Application for Certification (15-AFC-01)

Puente Power Project (P3)
Oxnard, CA

Responses to City of Oxnard Data Requests Set 4

December 2015

01/04/16 rks U:\Graphics\NRG Puente Power Project\DataRequest\Figs_DR_Jan4.indd

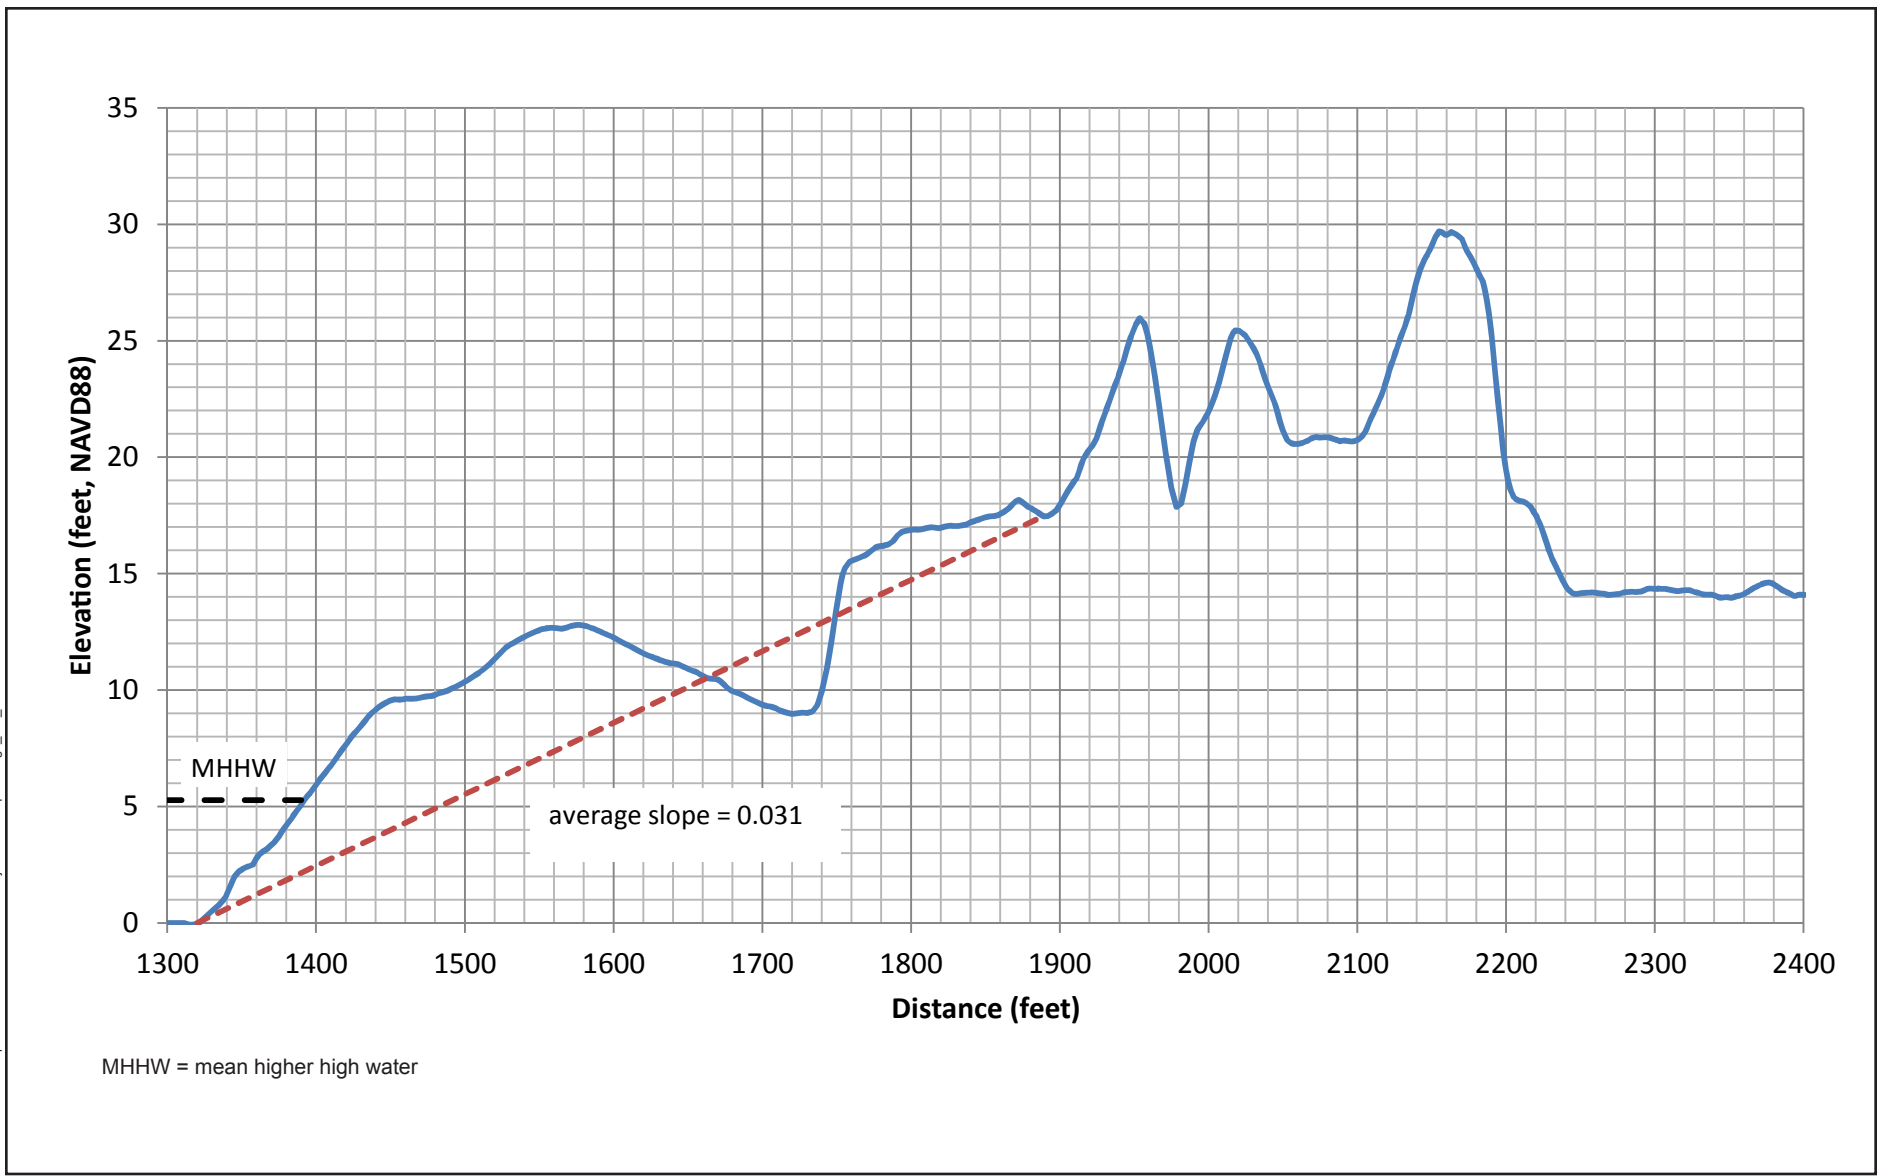
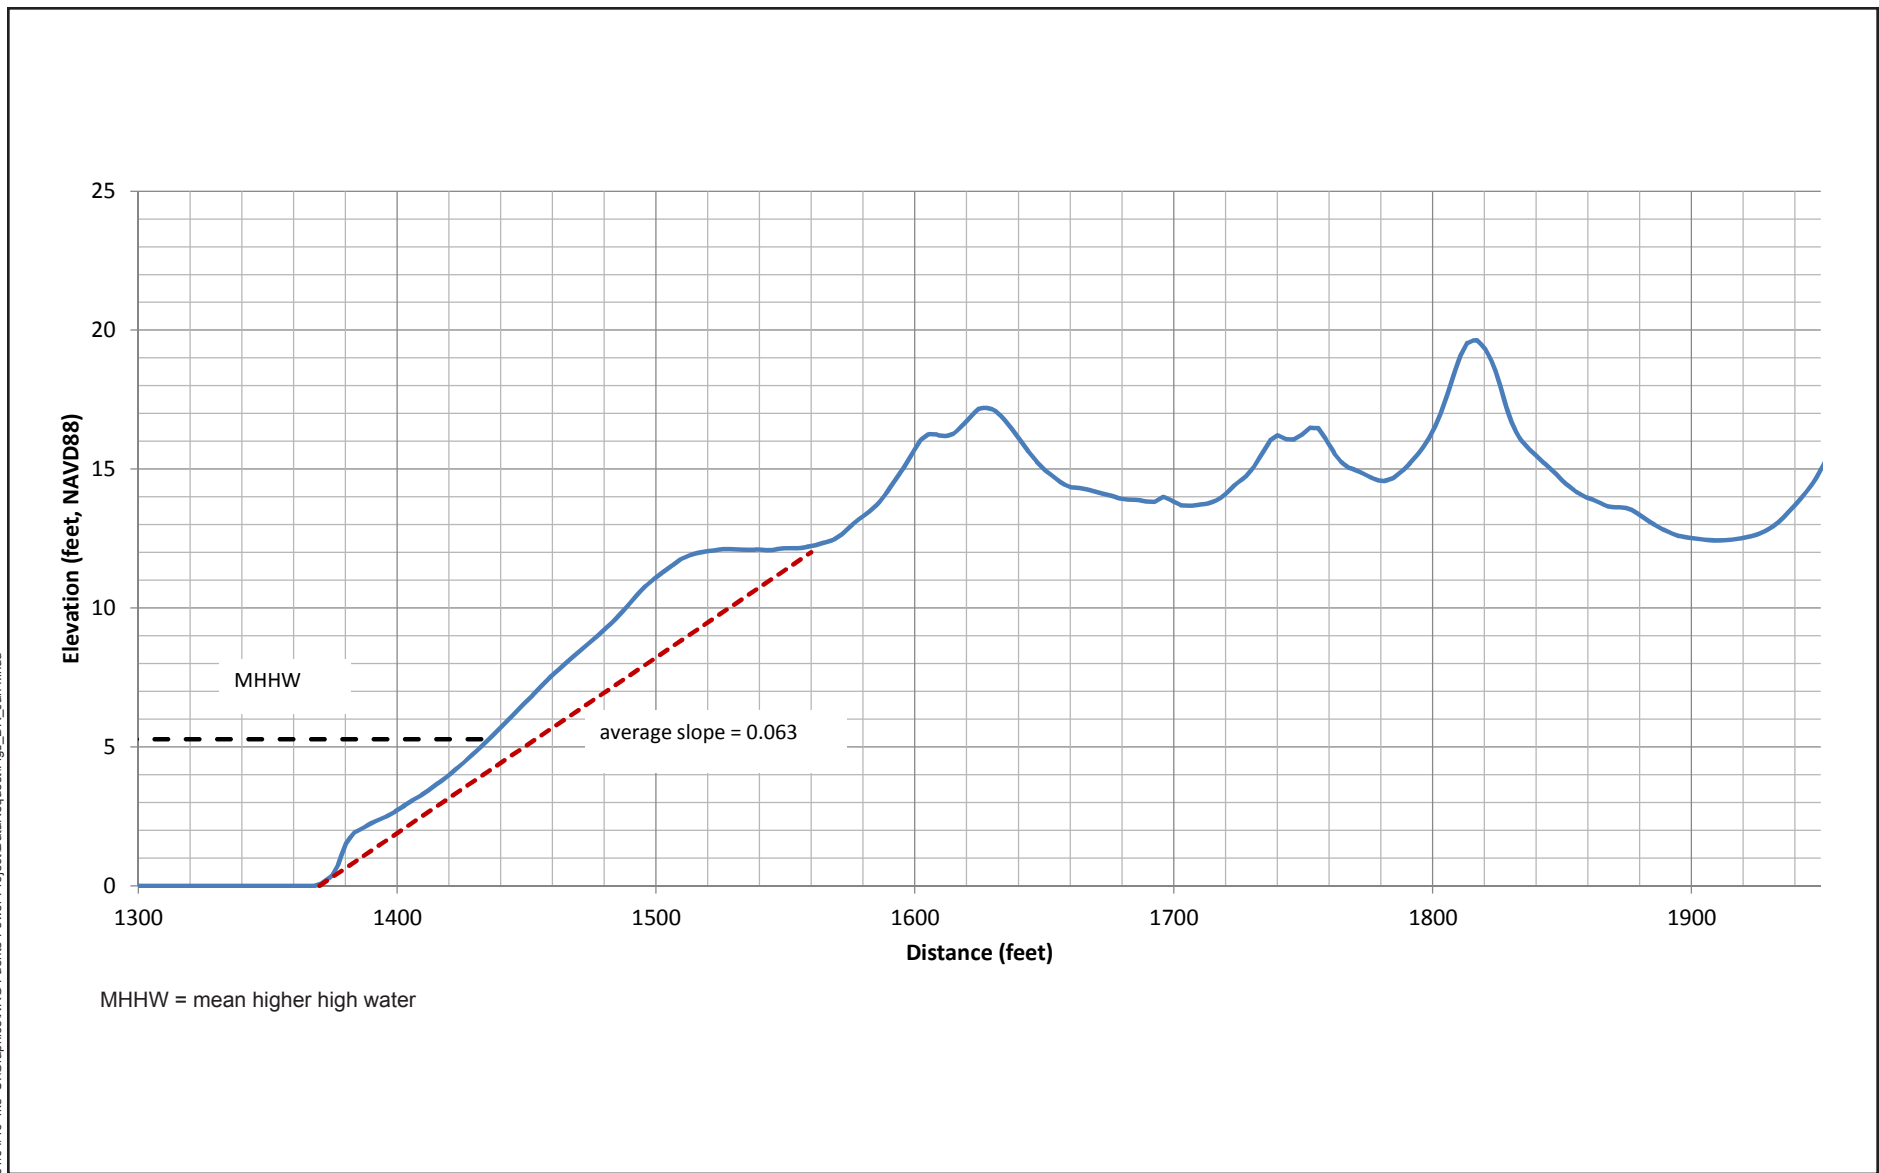
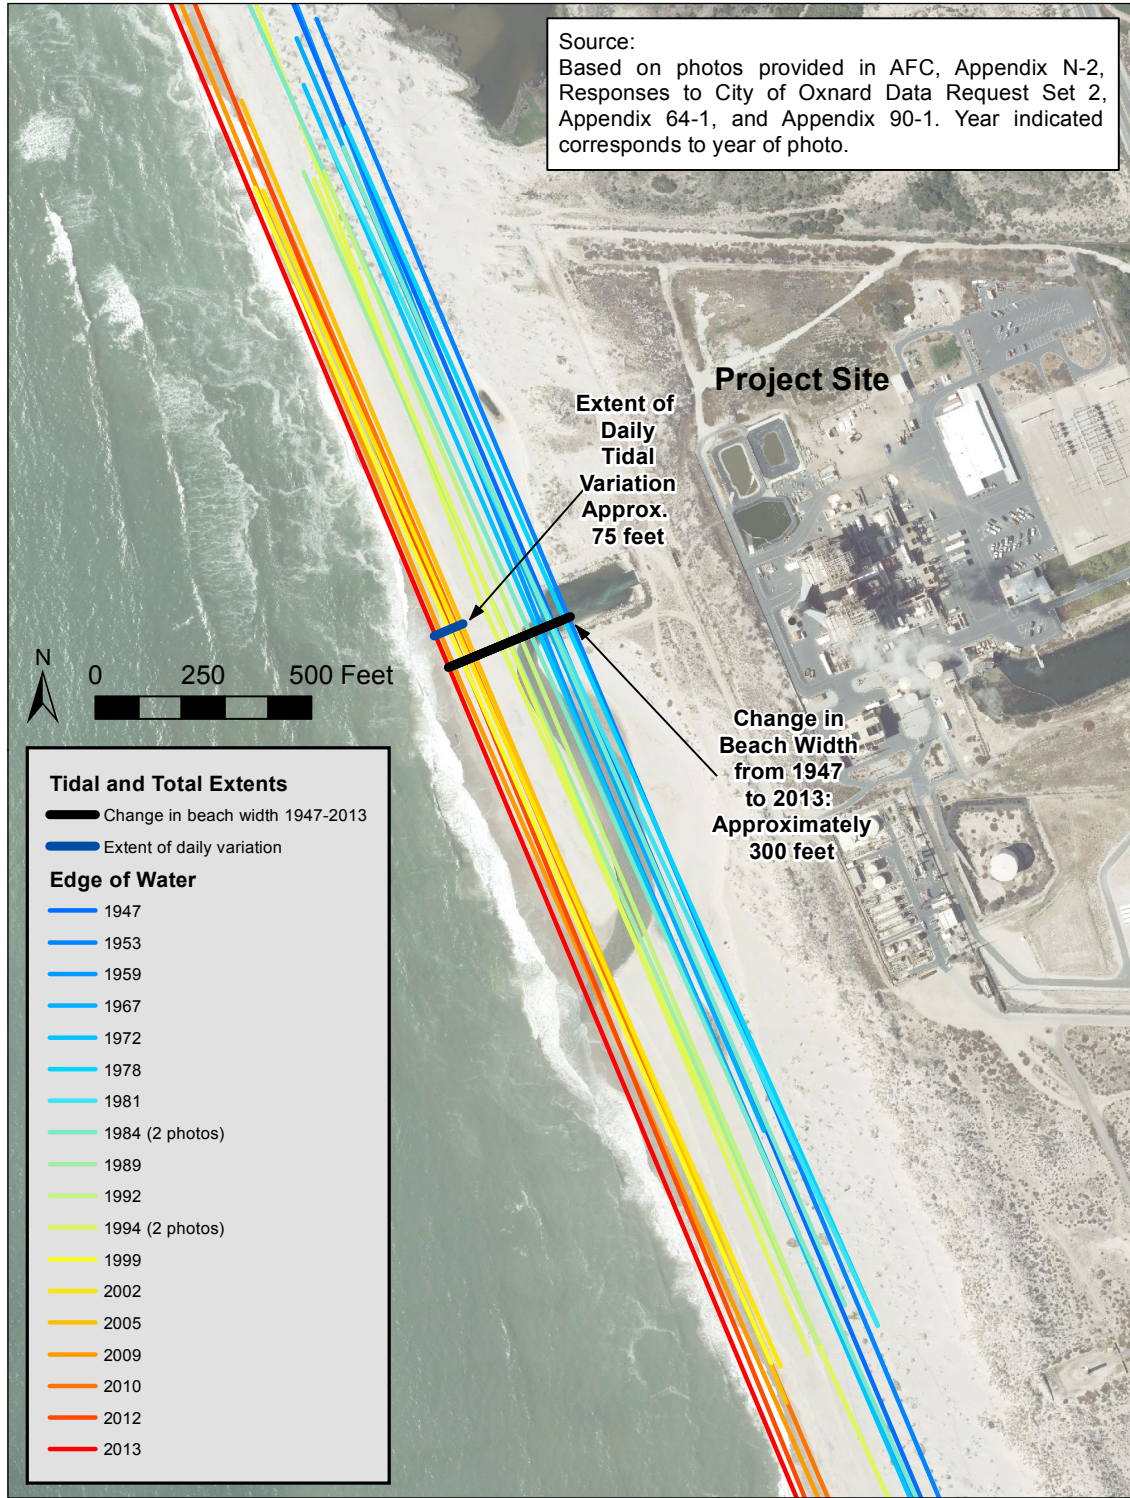
- 87. The applicant's responses to the City's Data Requests, Set 2 mention an average slope of Mandalay Beach calculated using beach profiles obtained from the 2013 LiDAR data. Please provide the beach profiles used to calculate the average slope of Mandalay Beach.**

Six profiles were developed from the most currently available LiDAR data. It should be noted that the LiDAR data were published in 2013, but the data are from 2009-2011, as explained in the response to Data Request 84. The locations of the profiles are shown on Figure 87-1. The individual profiles are shown on Figures 87-2 through 87-7. Figure 54-1 shows the idealized beach dune system assumed for calculation of dune erosion using the method described in Komar et al. (1999). The average beach slopes shown on Figures 87-2 through 87-7 were selected to be consistent with the conservative Komar et al. (1999) method, as explained in the response to Data Request 54. The average beach slope is approximately 3 percent, based on the six profiles. The LiDAR data used to compute the beach slopes for each profile are provided in Appendix 87-1.

APPENDIX 90-1
AERIAL PHOTO - APRIL 19, 2013

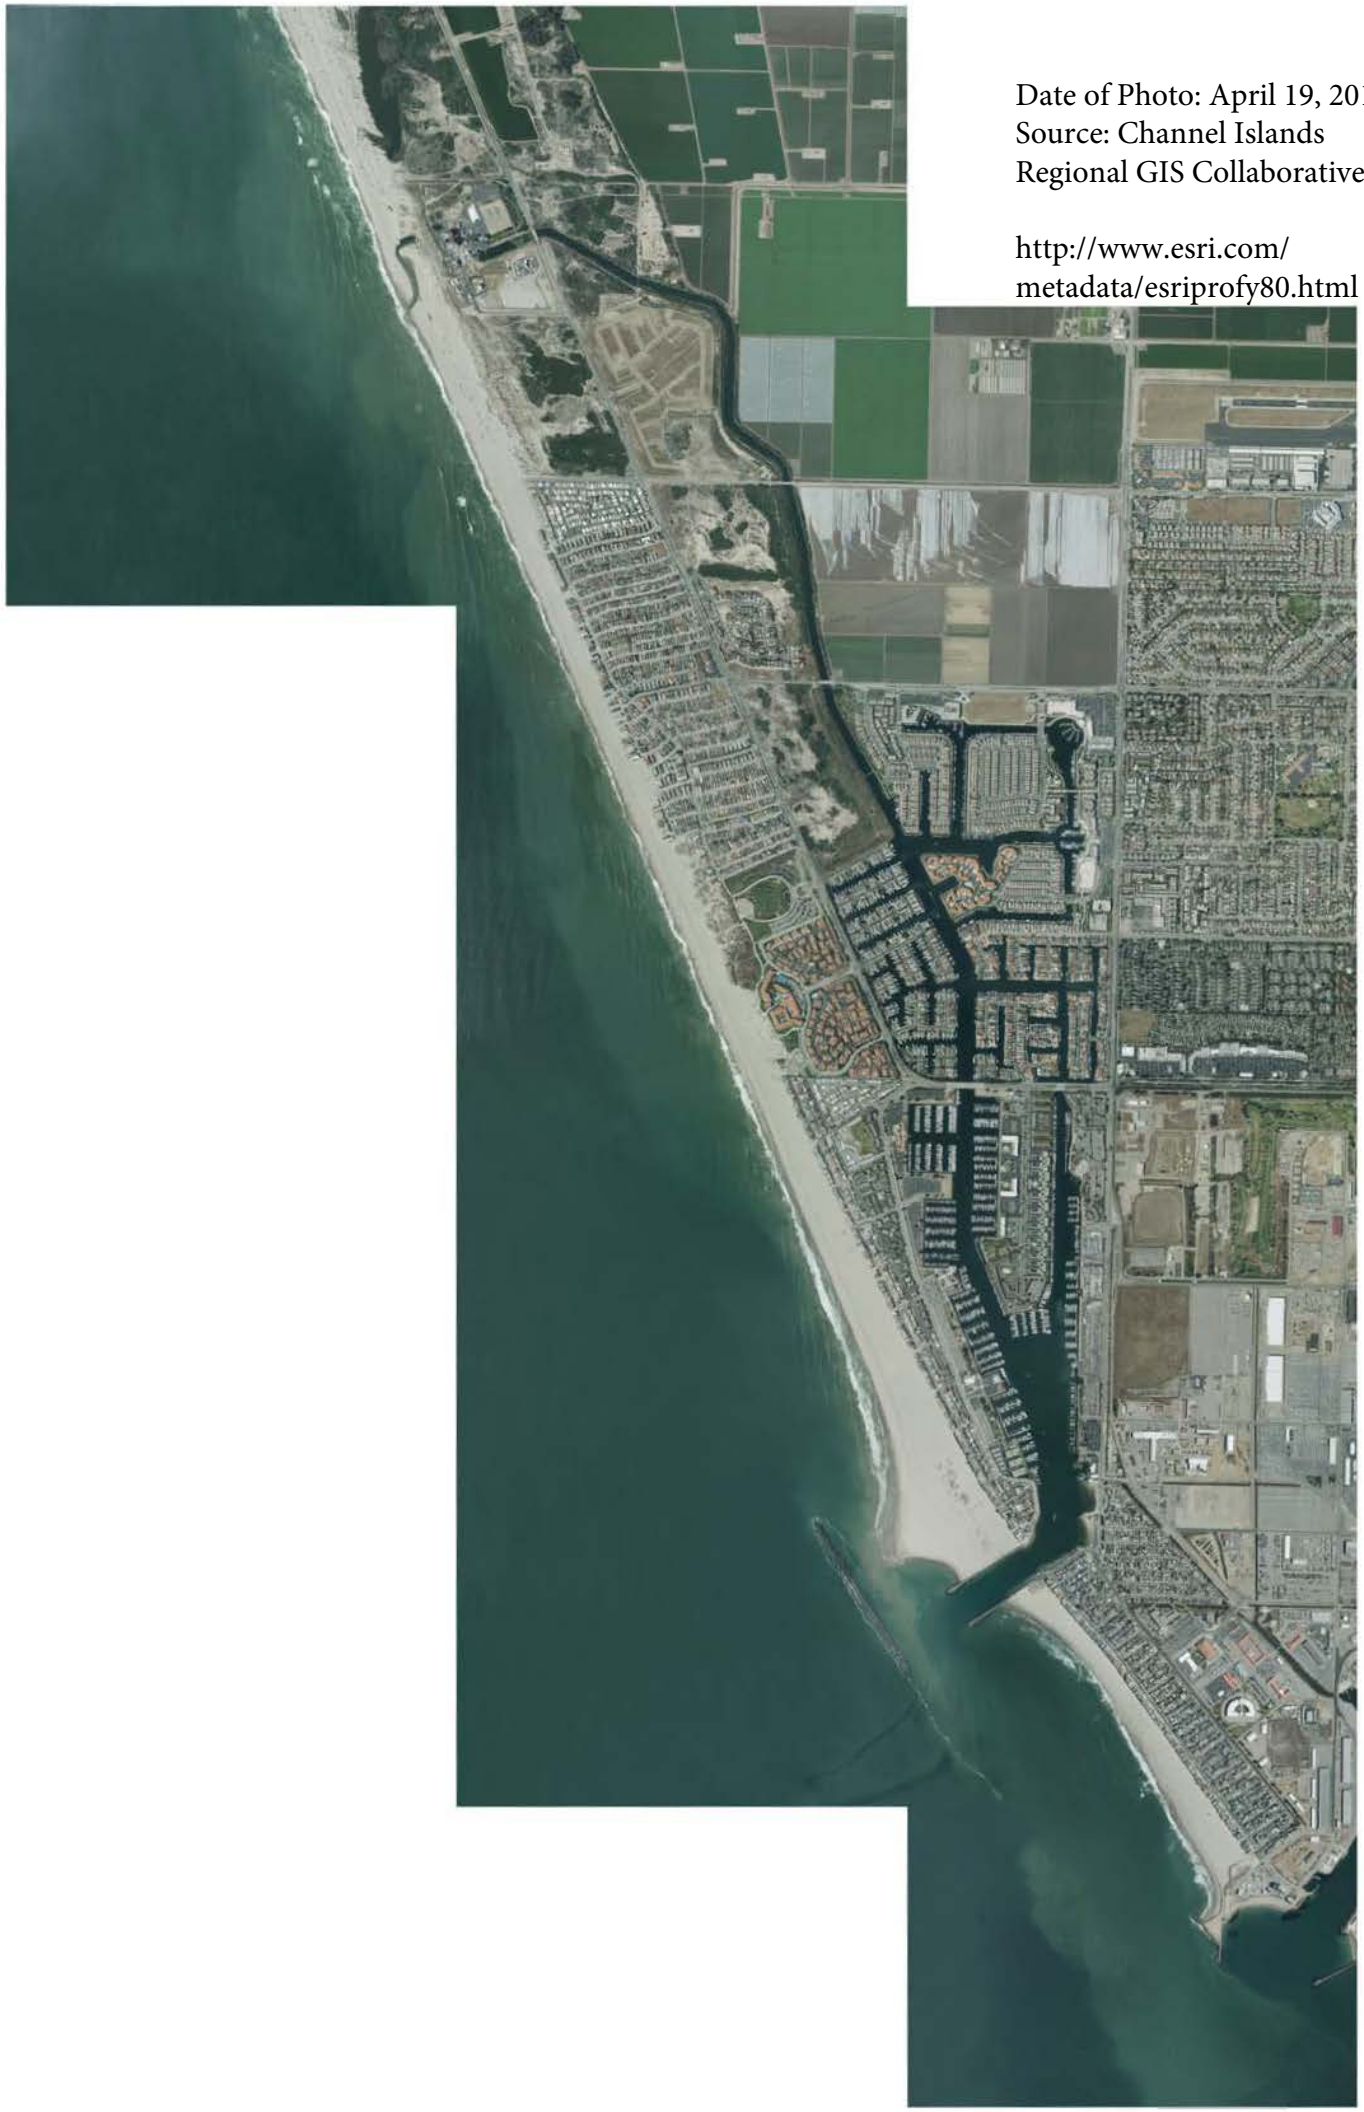
90. ***The responses state that the water lines represented in Figure 56-2 were developed by overlaying the water lines from historic aerial photos. Please fully describe the method used to register (georeference) the air photos used for Figure 56-2, and the requested revision to Figure 56-2.***

Most of the aerial photographs provided in the various Applicant submittals were obtained as aerial images or digital files that were not geo-referenced. The images were geo-referenced using the Geo-referencing toolbar in ArcGIS 10.2. All post-construction of the MGS images were geo-referenced to an ortho-rectified image created by the CIRGIS. Photos for the CIRGIS project were taken on April 19, 2013 (see Appendix 90-1). Metadata for the CIRGIS imagery can be found at:
